NP-12-0029  
July 10, 2012

Subject: Exelon Nuclear Texas Holdings, LLC  
Victoria County Station  
Early Site Permit Application  
Environmental Report – Partial Response to ER RAI Letter No.14  
Docket No. 52-042

References: (1) USNRC letter to Ms. Marilyn C. Kray, Environmental Request for Additional Information Letter No.14 Related to Meteorology & Air Quality for Victoria County Station Early Site Permit Application, dated May 31, 2012

## Annual Wind Rose (July 1, 2007 through June 30, 2009)

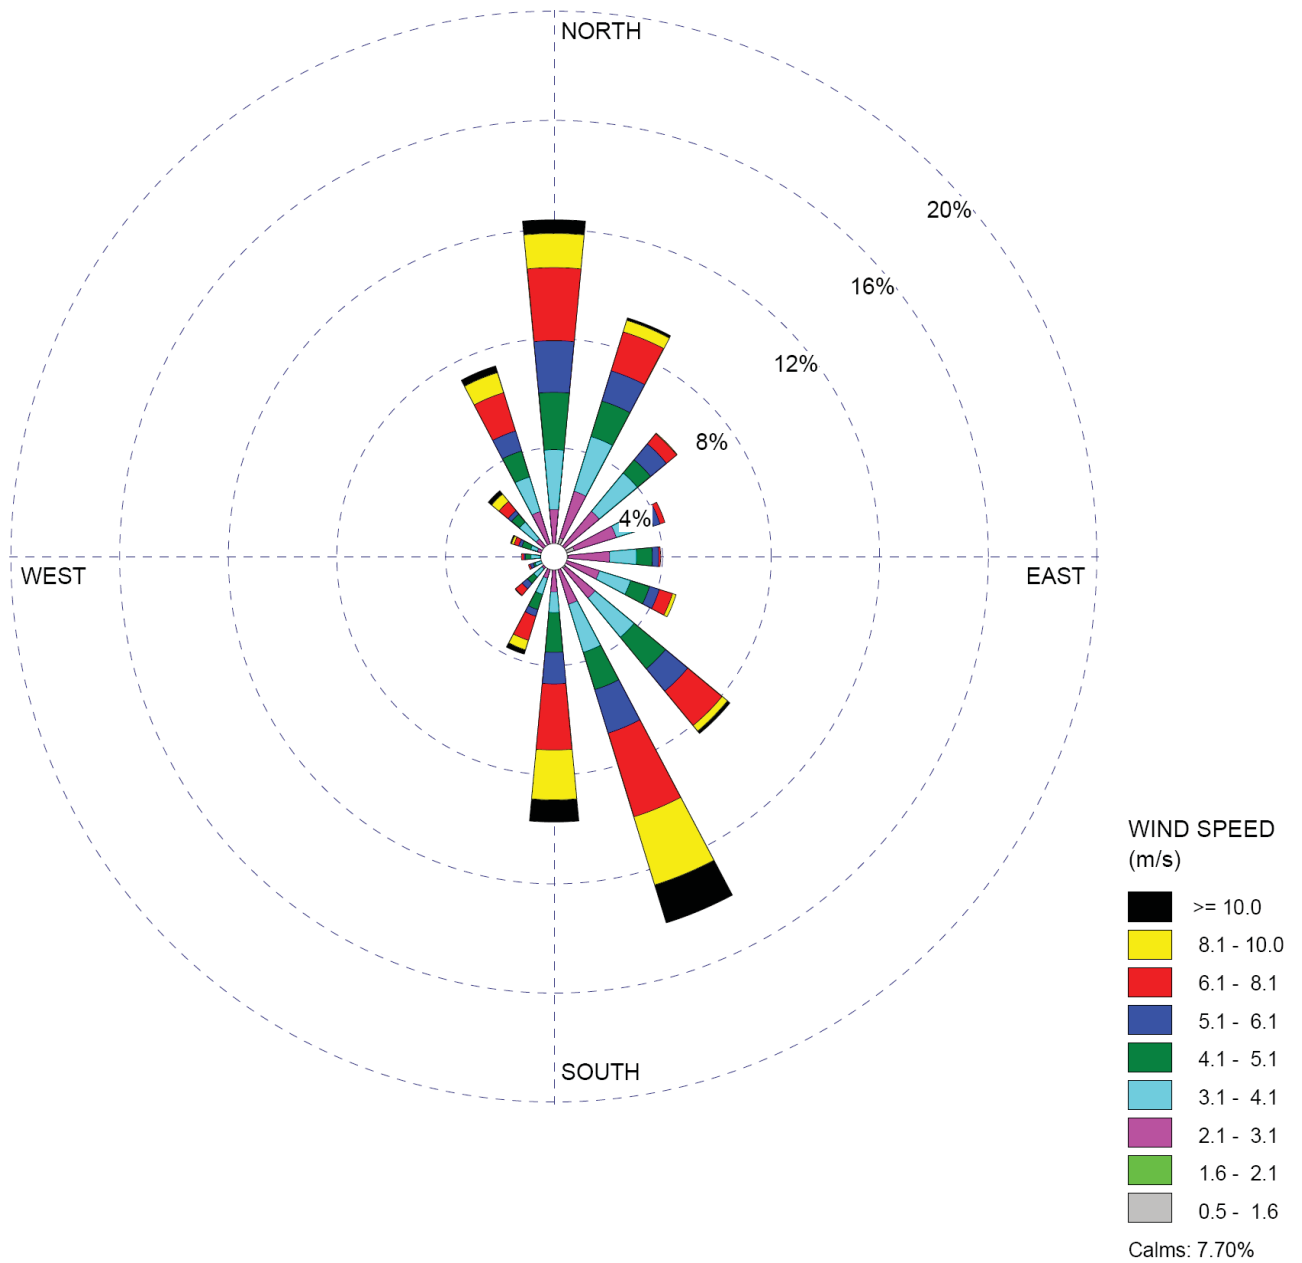
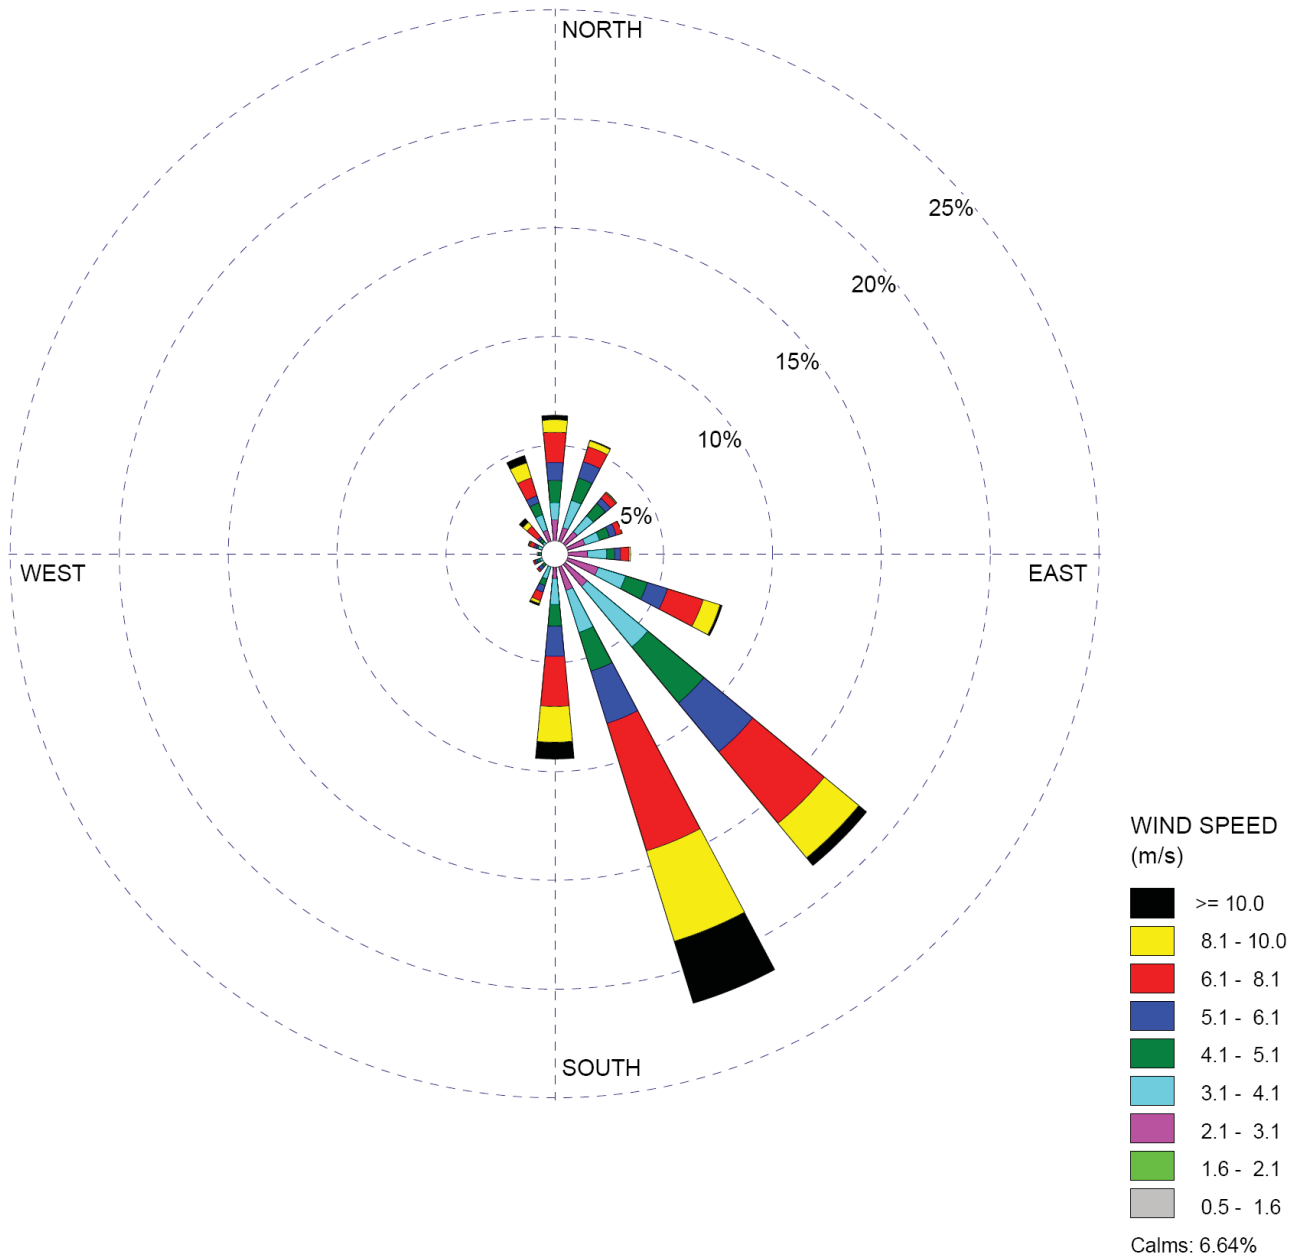
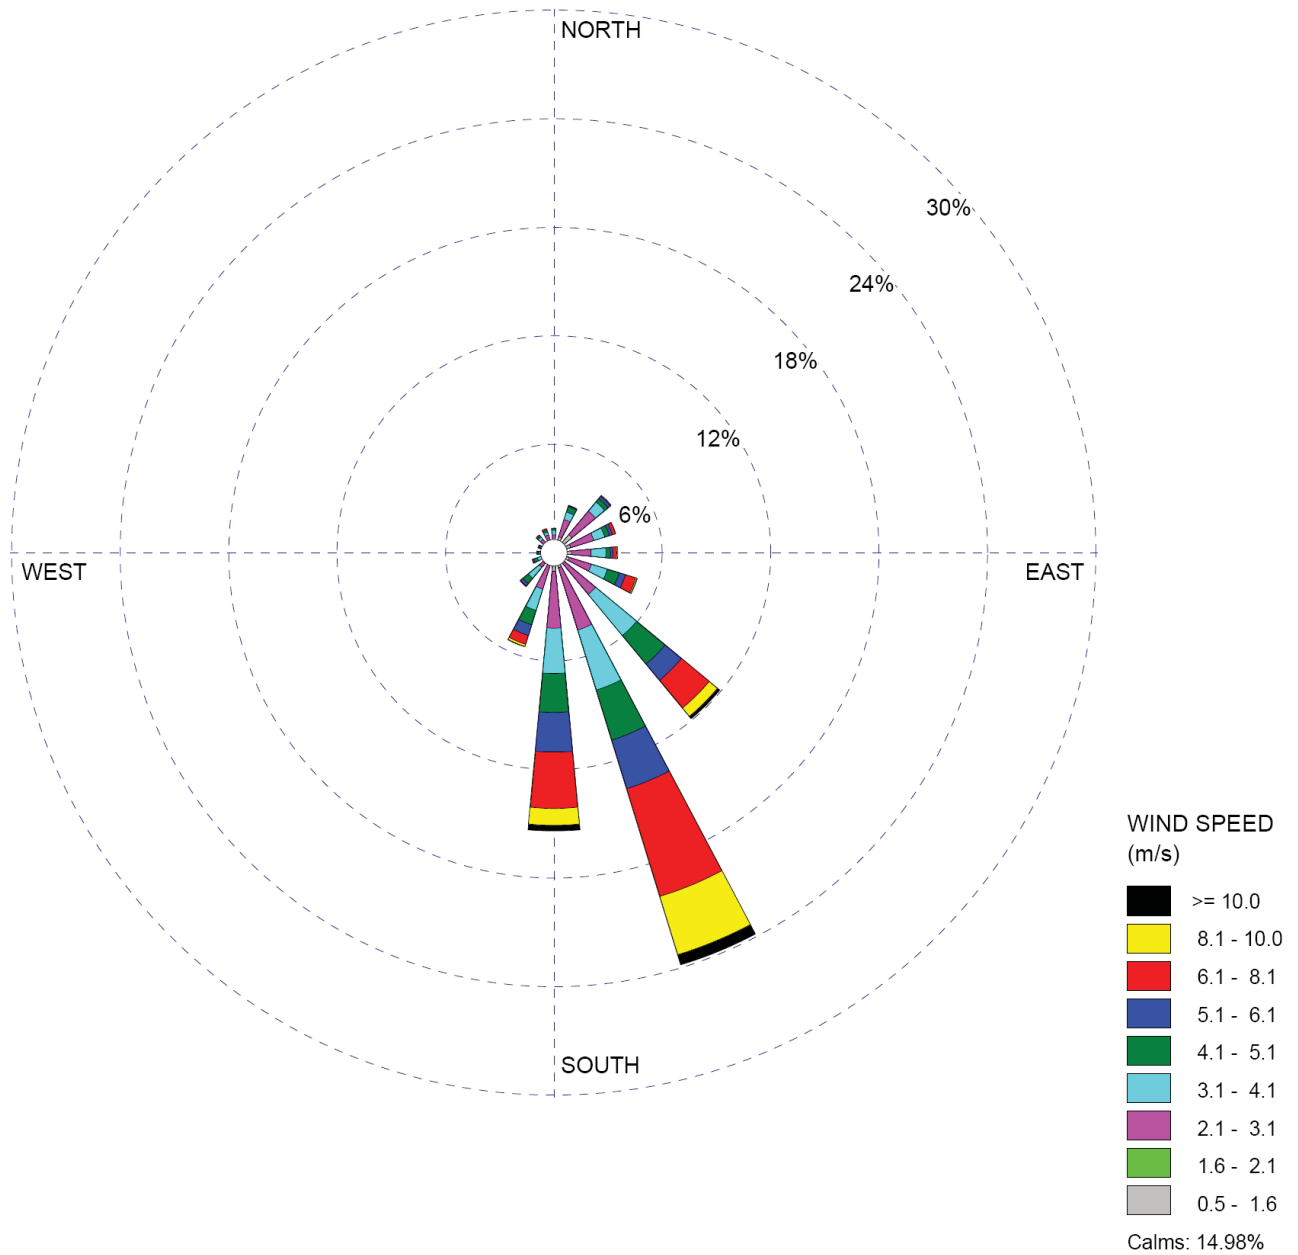
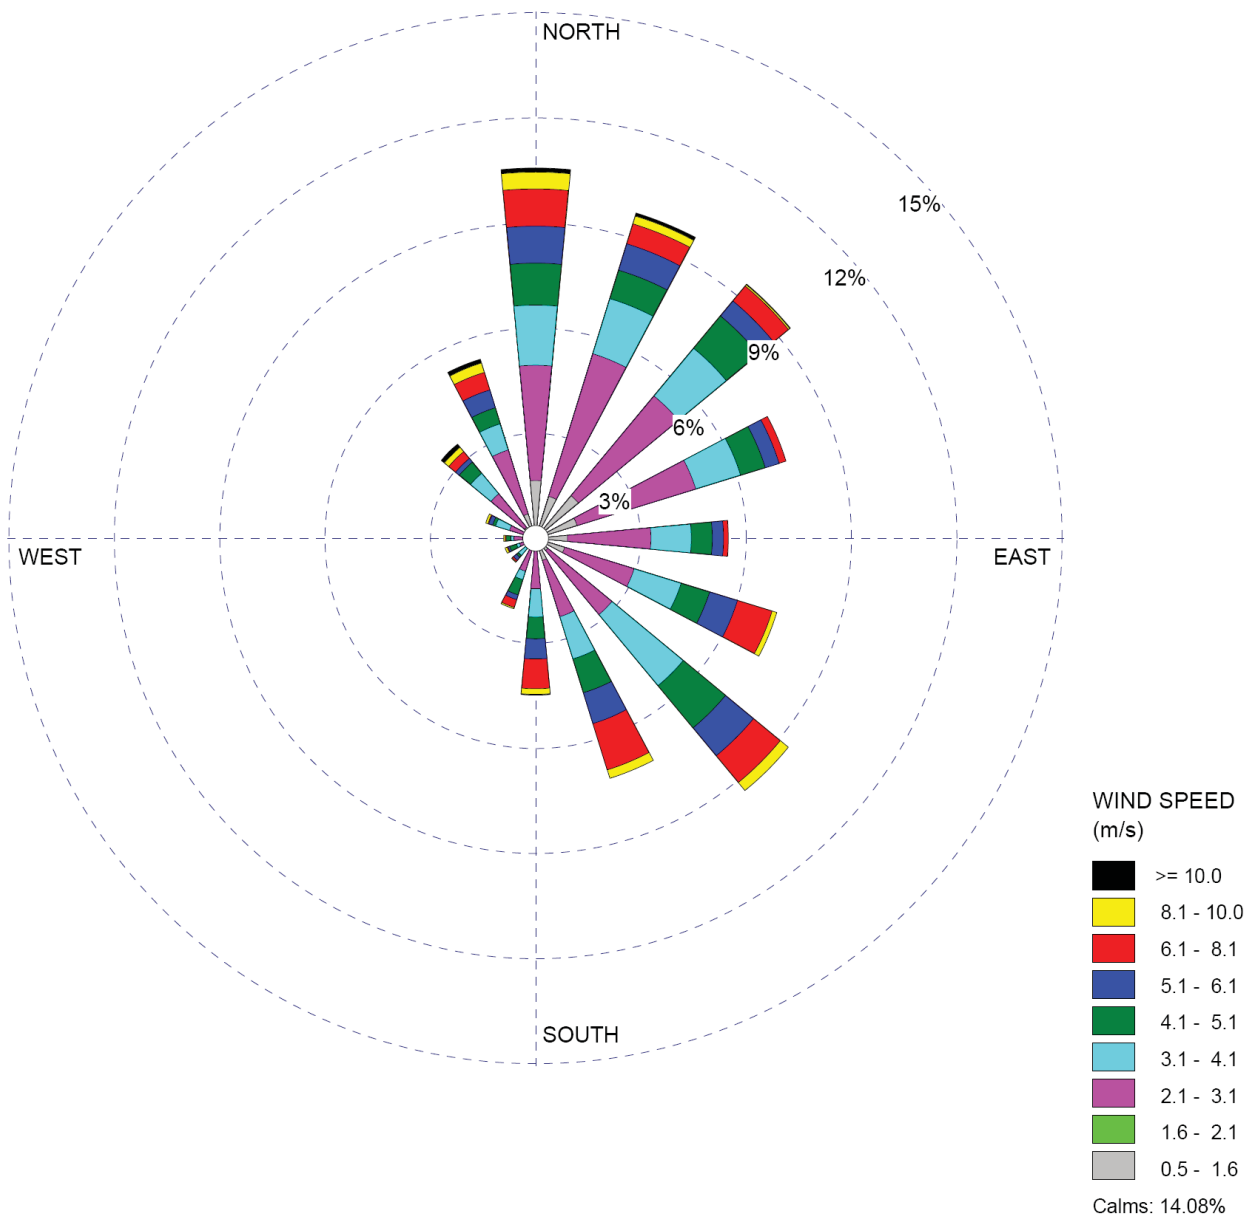
MET-1 - ESRP Section 2.7 directs the staff to review the applicant's meteorological monitoring program for obtaining data that are representative of the site. Section 2.7 (page 2.7-6) states "at least one annual cycle from the onsite meteorological program should be used to relate local meteorological conditions to local and regional climatology". In order to determine if the measurements taken at the VCS site are representative of the weather in the region, the NRC staff requests that the applicant provide annual and seasonal wind roses for Victoria National Weather Service (NWS) station for the same 2-year period as the onsite meteorological data, for comparison to the 10-meter onsite wind data. Provide annual and seasonal wind roses for Victoria NWS station for the same 2-year period as the onsite meteorological data.

Two years (July 1, 2007 to June 30, 2009) of data from the National Climatic Data Center's (NCDC) Integrated Surface Hourly (ISH) website (Ref. 1) were downloaded and converted into seasonal and annual wind roses. Annual and seasonal wind roses from the Victoria, Texas, (KVTC) (provided on the following pages) were compared to those in ER Figures 2.7-2 through 2.7-6 and were found to support the conclusion that measurements taken at the VCS site are representative of the weather in the region. The topography in this region is generally flat, so little variation is found between the two sites (ER Fig. 2.7-1).
